MODIFICATION No. 20998/P01376

TITLE : AIR CONDITIONING - AVIONICS VENTILATION - IMPROVE SIGNIFICANT
SIGNALLING DEFINITION.

SERVICE BULLETIN No. : A320-21-1010

REVISION No. : 1 - Apr 24/89

Installation of Diaphragms on Air Conditioning Ducts Between FR21 and FR24.
Figure 1, Sheet 1 of 2

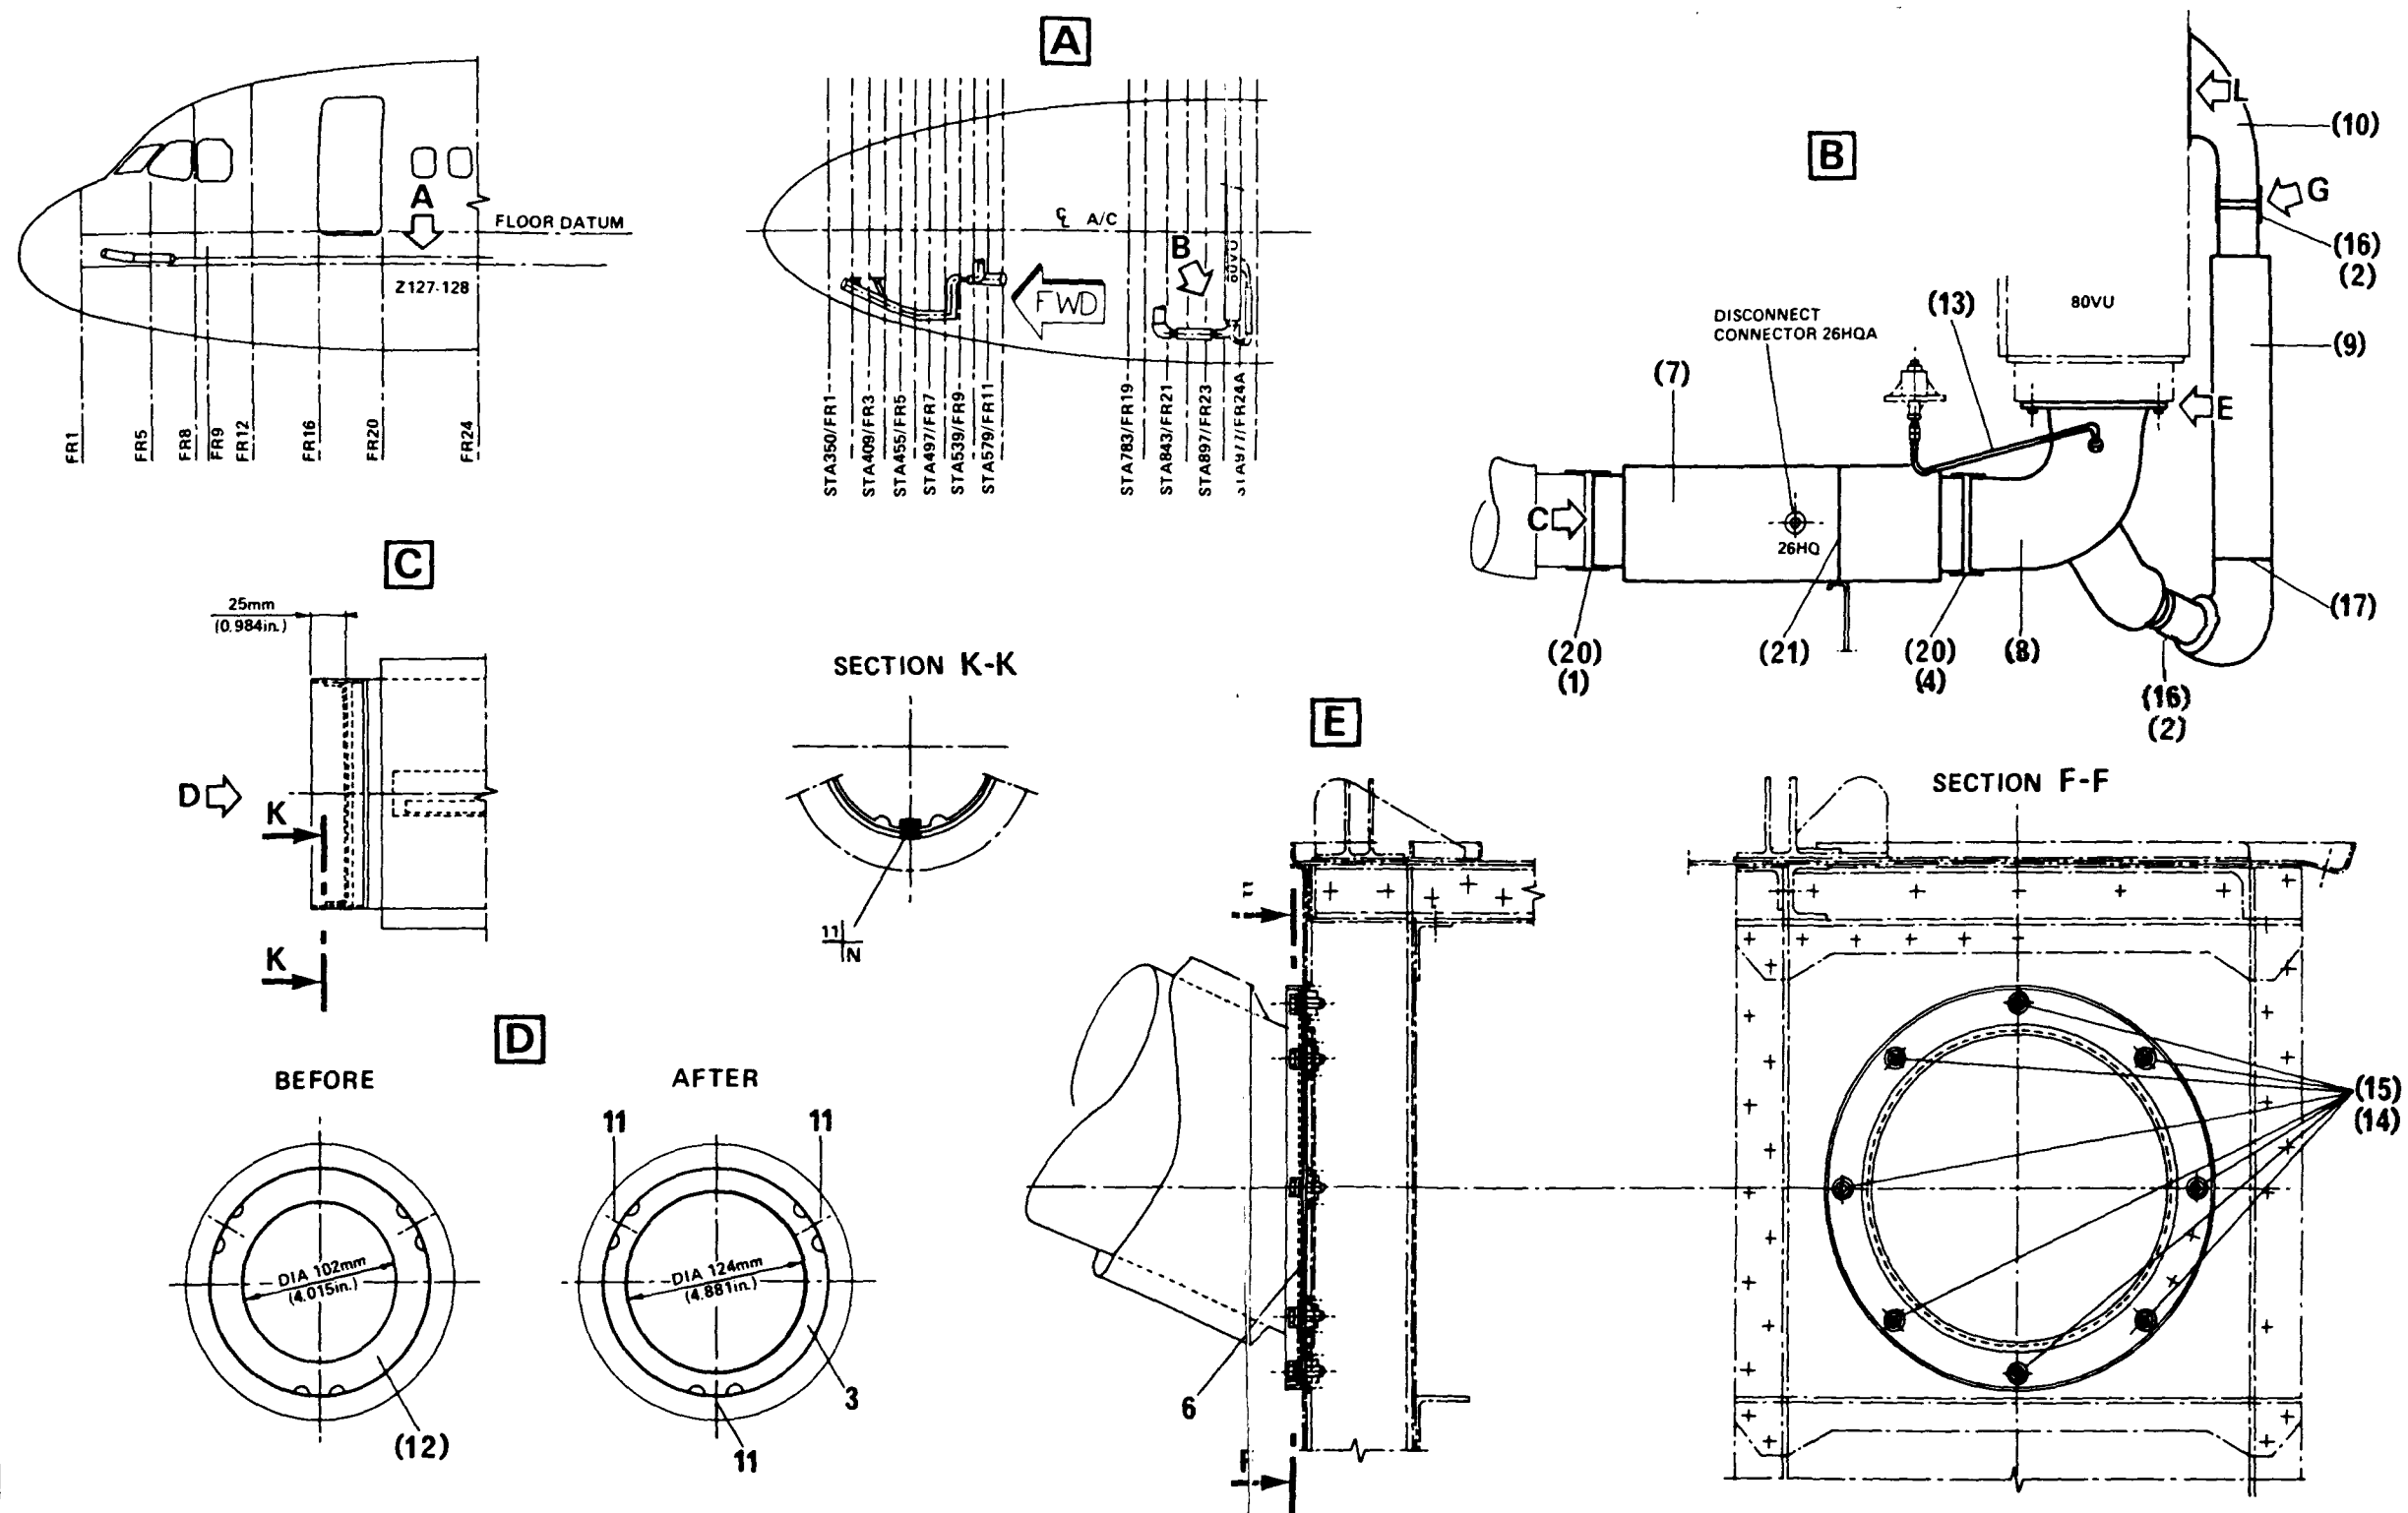
Ref. Fig. 1 Sheet 1 of 2 and 2

In forward cargo compartment and in zone 120 (80VU) between FR21 and FR24, left side, in air conditioning system, add and replace diaphragms.

(a) On duct Item (7) (Ref. Fig. 1, Sheet 1 of 2 Details C and D)

(c) On duct Item (8) (Ref. Fig. 1, Sheet 1 of 2, Detail E)

(e) On duct Item (10) (Ref. Fig. 1, Sheet 1 of 2 and 2, Detail G and H).

1 Diaphragm D2121033421000 Item 3
with
3 rivet L21217024008DCJ Item 11

Re-identify duct
D2121019800300 becomes D2121019800400

1 Diaphragm D2121104720000 Item 6 and install :

1 Diaphragm D2121054520200 Item 4
with
3 Rivets L21217024008DCJ Item 11

Re-identify duct
D2121022700000 becomes D2121022700200

Installation of Diaphragms on Air Conditioning system Between FR3 and FR11
Figure 2

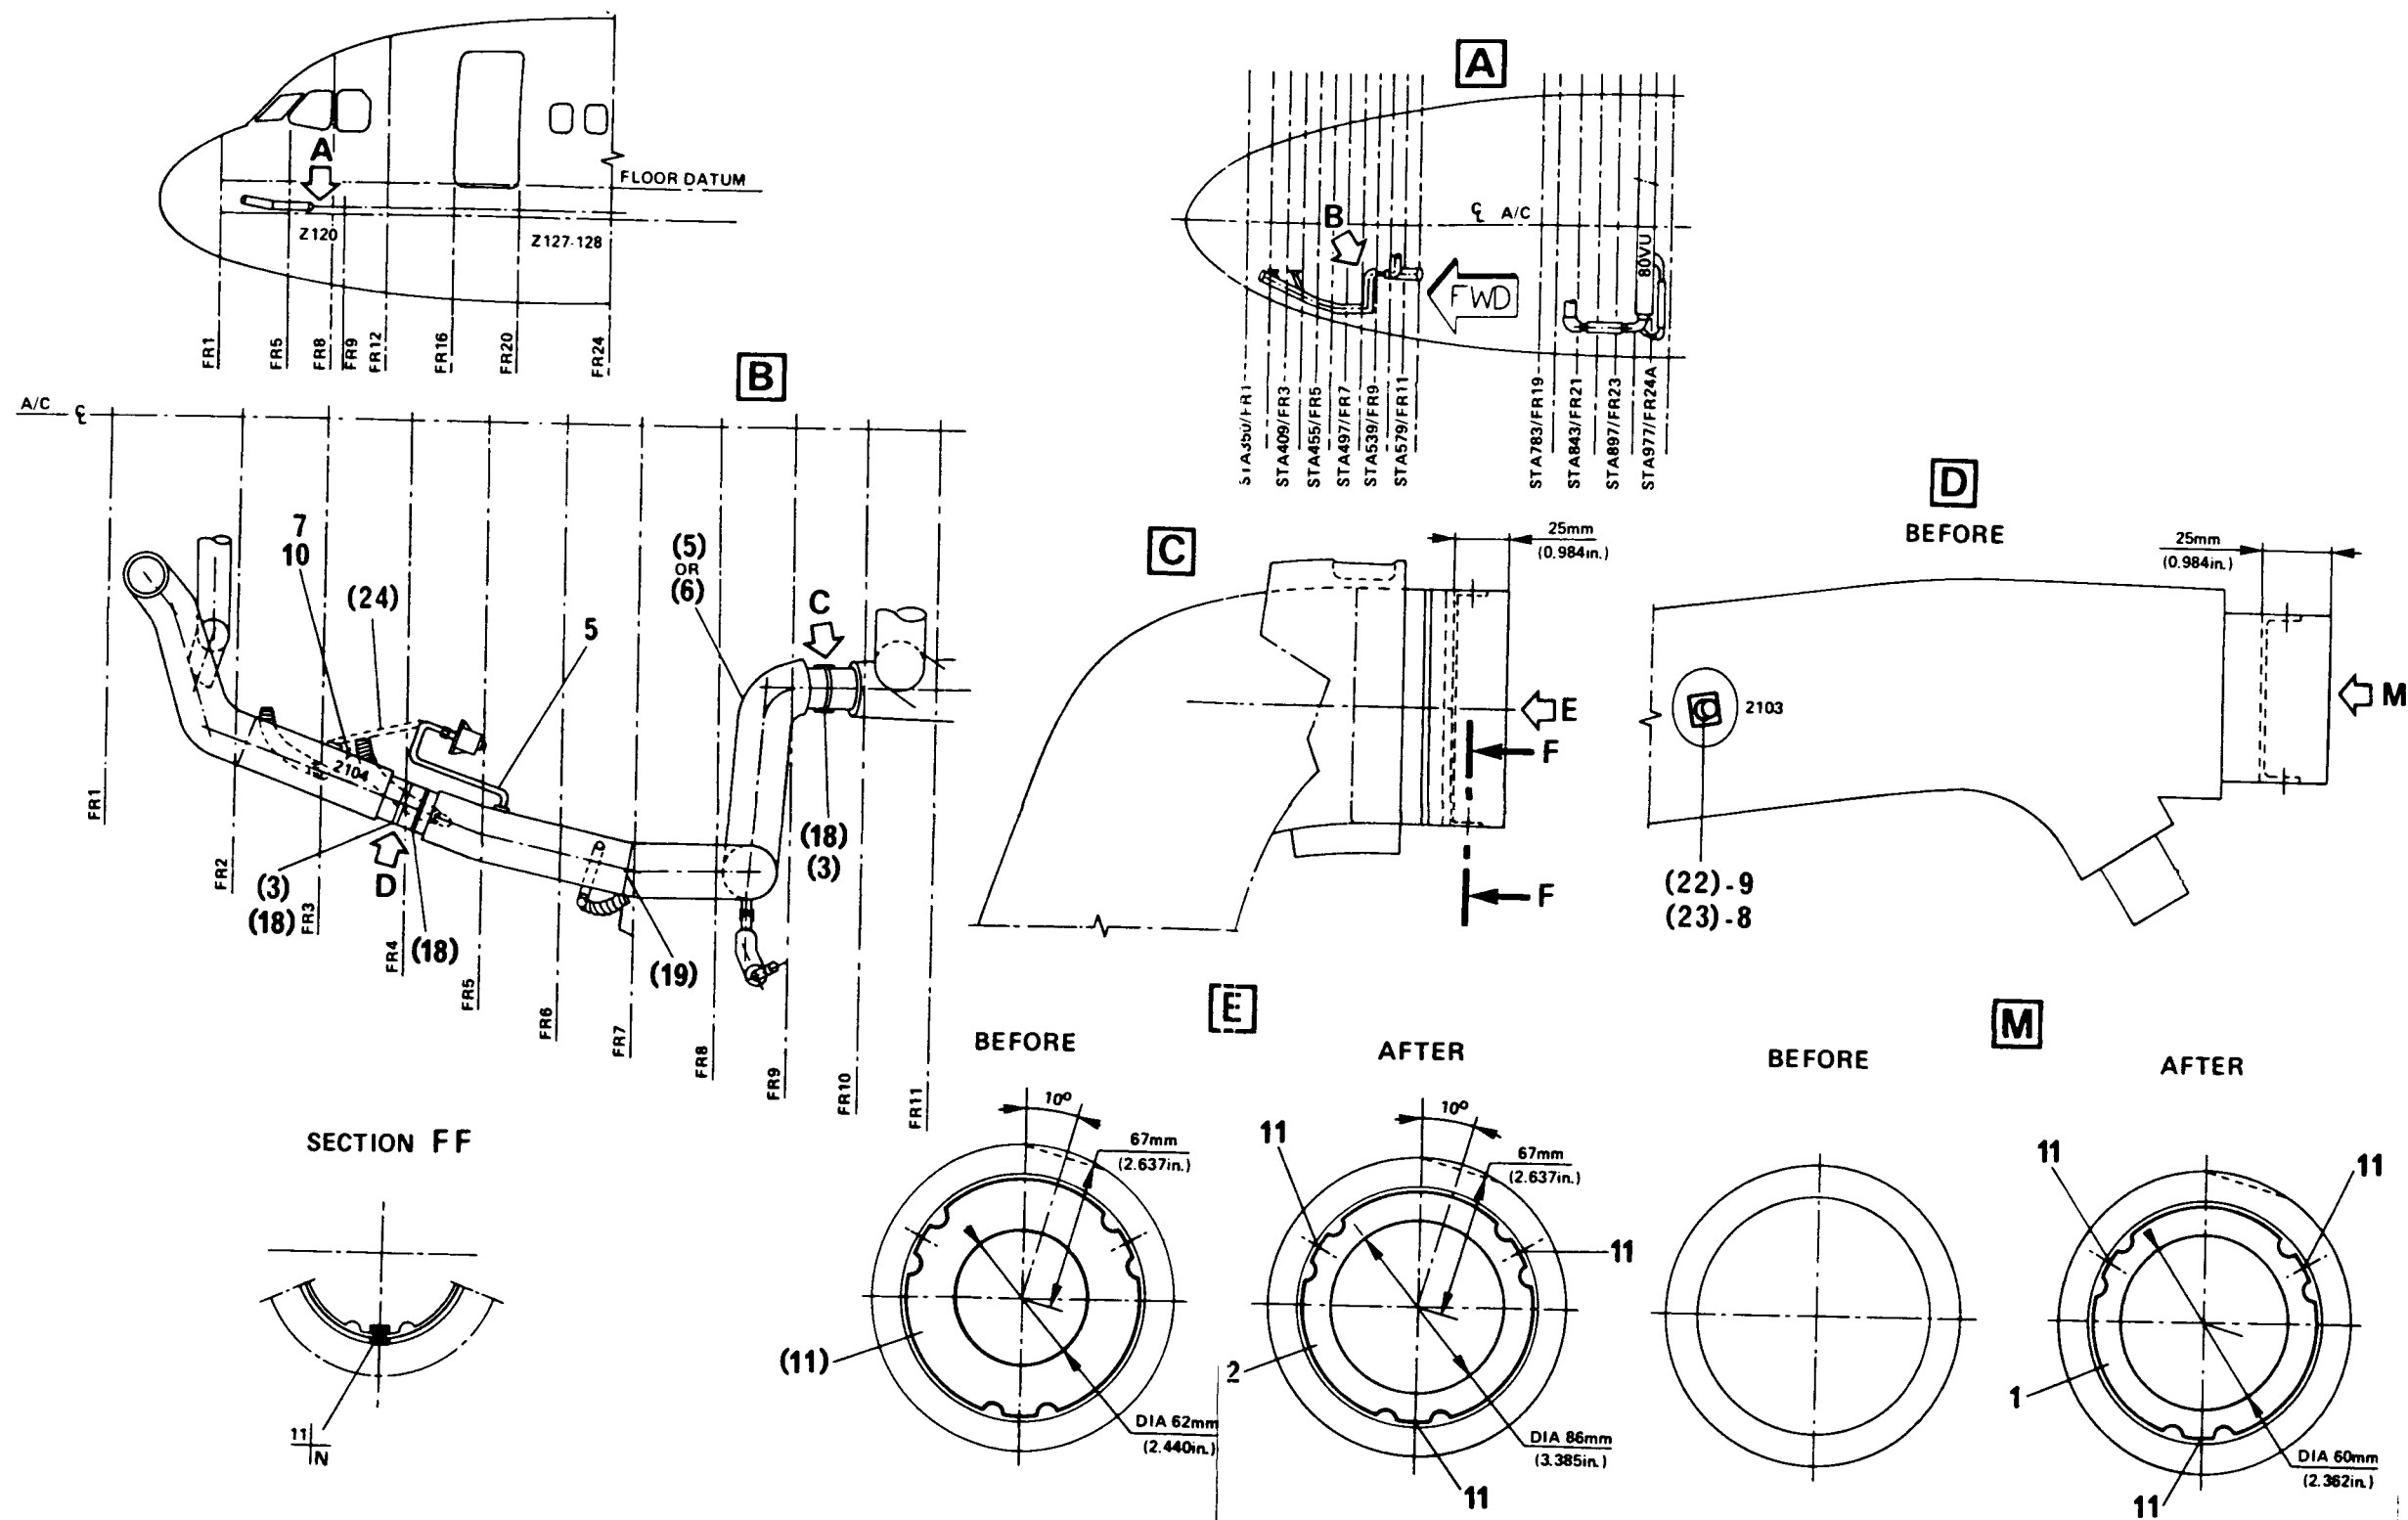
Ref. Fig. 2

In cargo compartment, zone 120 STA495 (90VU) and zone 120 STA655 (106VU) between FR3 and FR11, left side, air conditioning system, replacement of diaphragms and installation of duct.

(a) On duct Item (5) or (6) (Ref. Fig. 2, Detail C and E),

(c) On duct (5) or (6) (Ref. Fig. 2, Detail D and M),

1	Diaphragm D2121033121000	Item 2
	with	
3	Rivet L21217024008DCJ	Item 11

1	Diaphragm D2121033120800	Item 1
	With	
3	Rivet L21217024008DCJ	Item 11

D2121017600000	becomes	D2121017600400
D2121017600200	becomes	D2121017600500

1 Coupling MS21902D4	Item 9
1 O-ring NSA8202-5	Item 8

1 Seal NSA8202-4	Item 7
1 Blanking plug MS21913D4	Item 10

1 Duct D2121065900300	Item 5
-----------------------	--------
